ADDENDUM NO. 001

PROJECT INFORMATION: Porterville College Asphalt Repairs Parking Lot A & B
(North Parking Lot)

Addendum Dated:
4/2/26

REVISED ASPHALT
SEAL AND STRIP PLAN
3/31/26

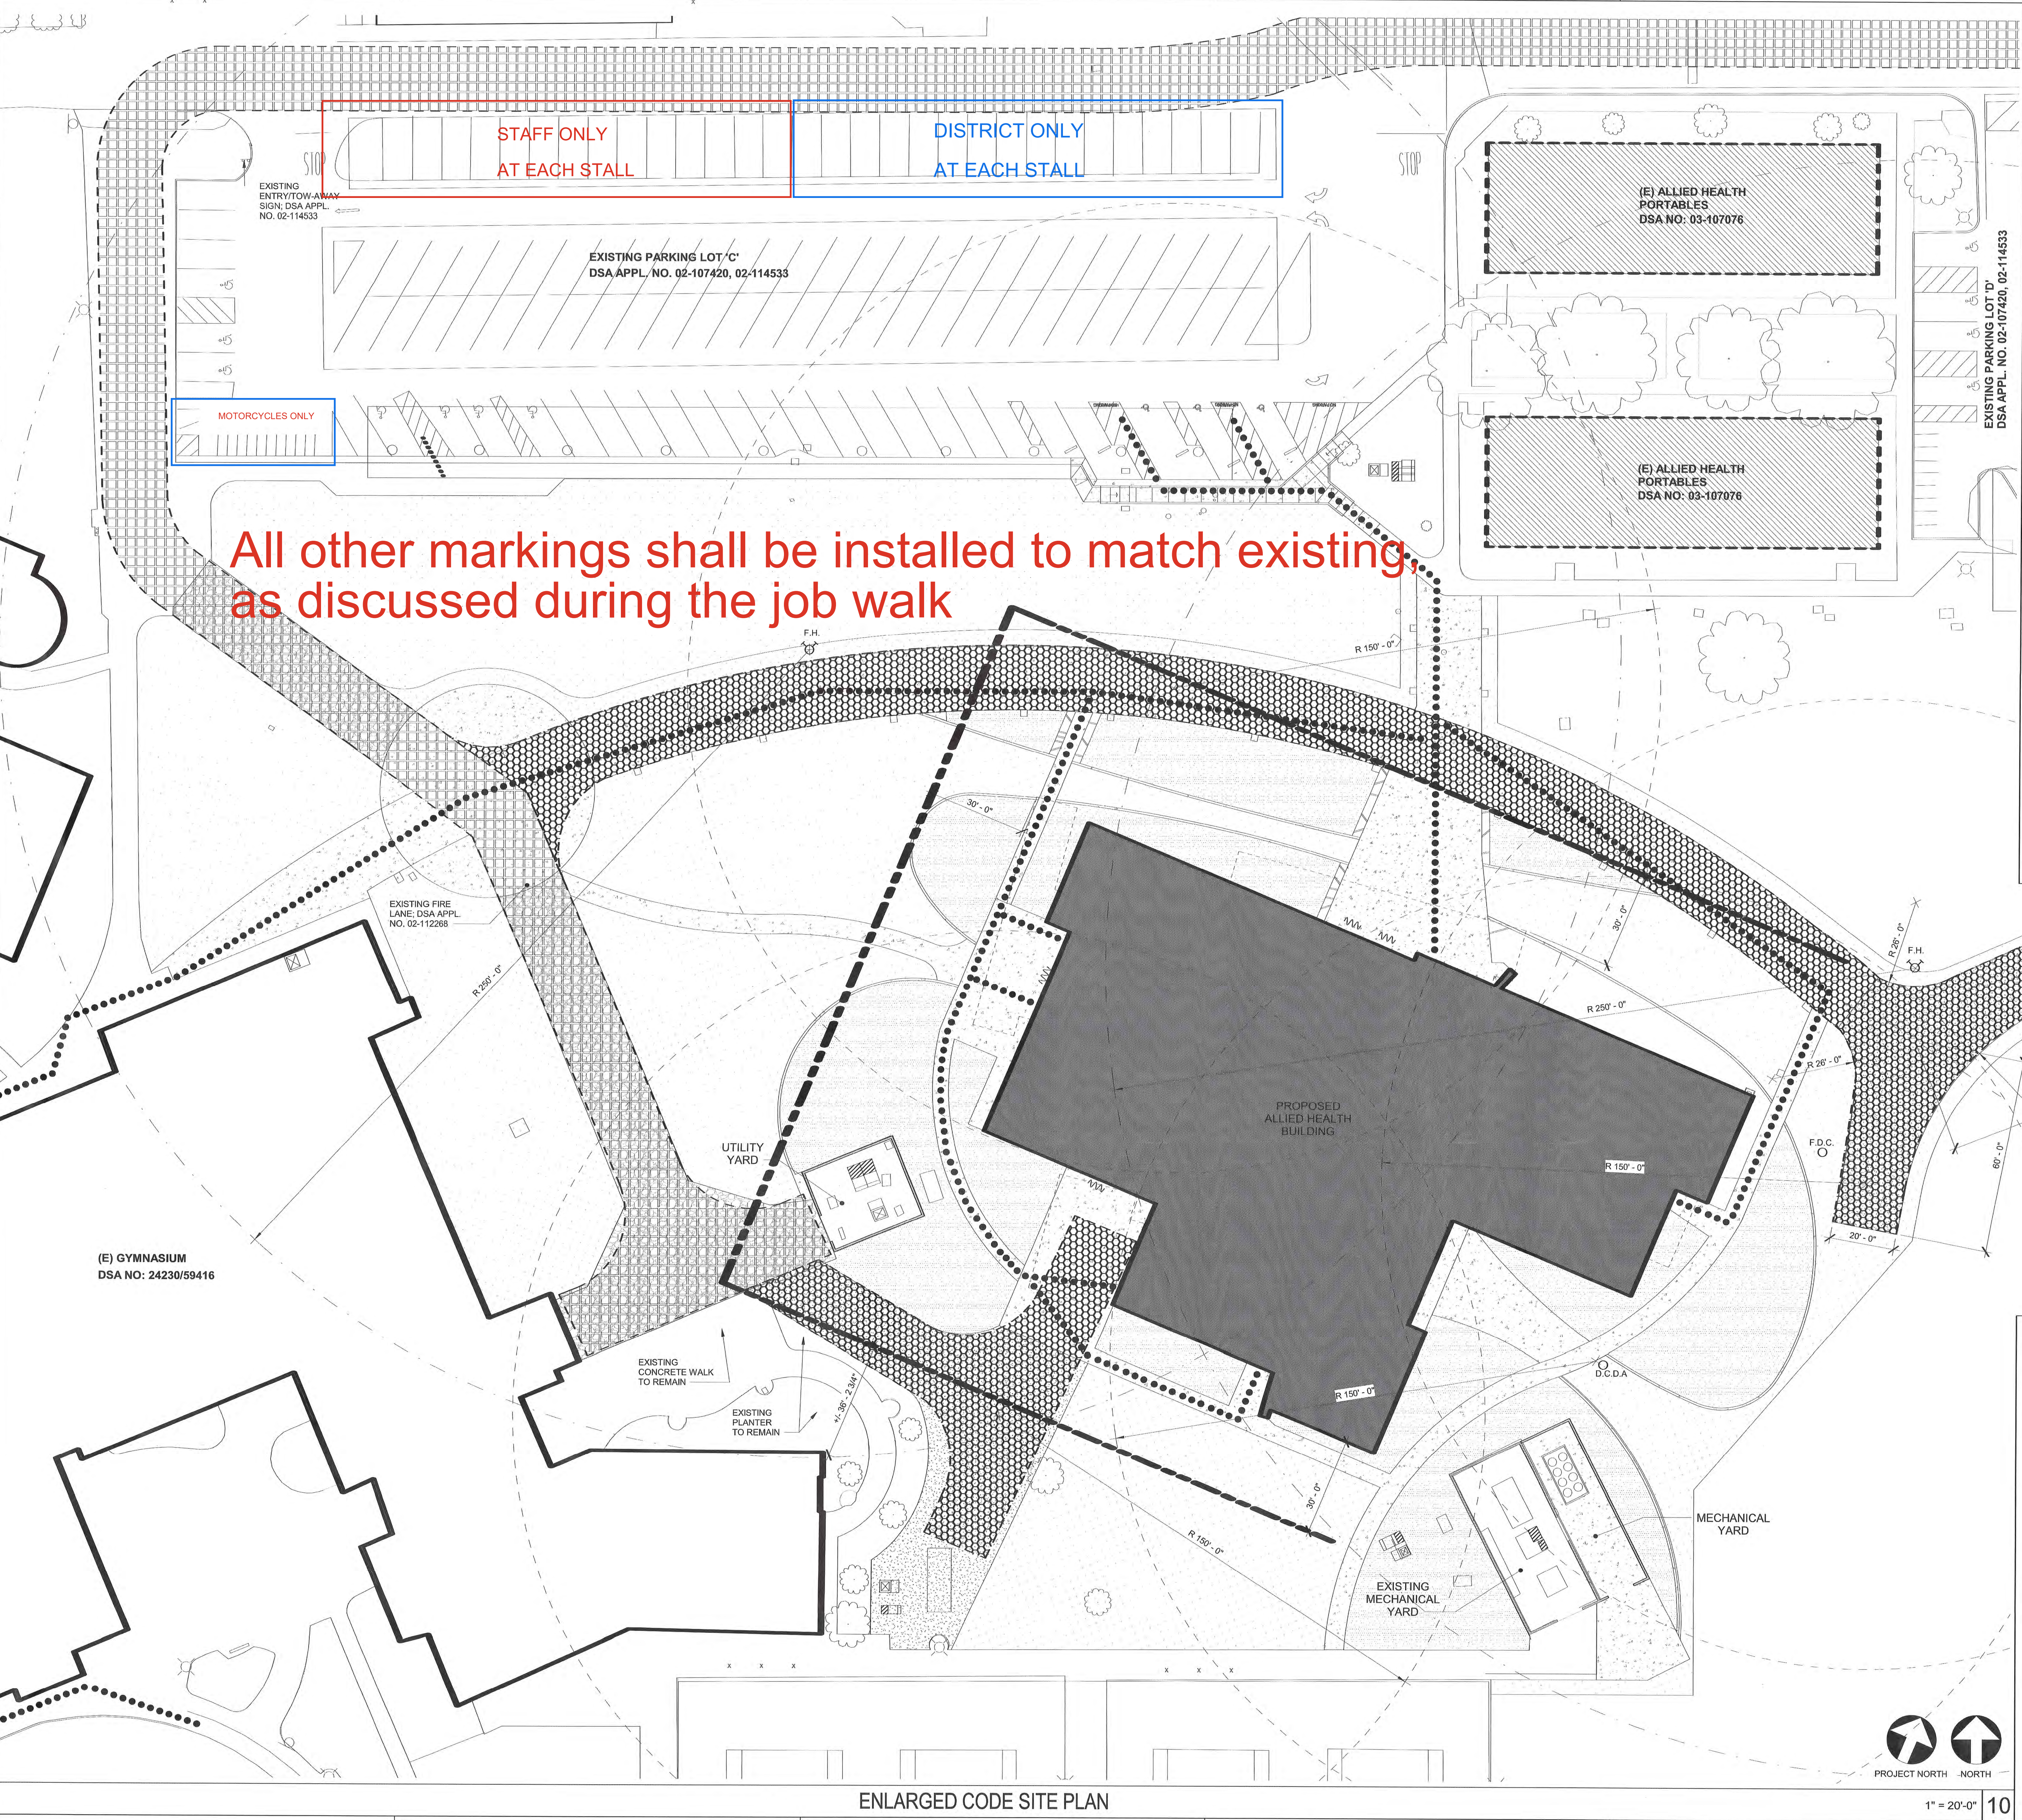
1. The attached drawings revise the scope of work for asphalt seal coating. The two north parking lots will not be resealed, as originally discussed during the job walk. Additionally, the west section of the fire lane, up to the gate, will not be resealed as shown on the original plans.
2. The small storage laydown area will be resealed at a later date (late summer) after all items have been removed.
3. Parking stalls shall be striped in accordance with the attached drawings. All other pavement markings shall be installed to match existing conditions, as discussed during the job walk.

Asphalt area to be completed after
furniture is removed at the end of
summer.

FOR DELIVERY ONLY

STAFF ONLY
AT EACH STALL

NO PARKING

ADA
STALLS
REMAIN
THE SAME

NO PARKING
W/ HASH LINES

INSTALL (4)
48"
CONCRETE
BUMPER

All other markings shall be installed to match existing, as discussed during the job walk
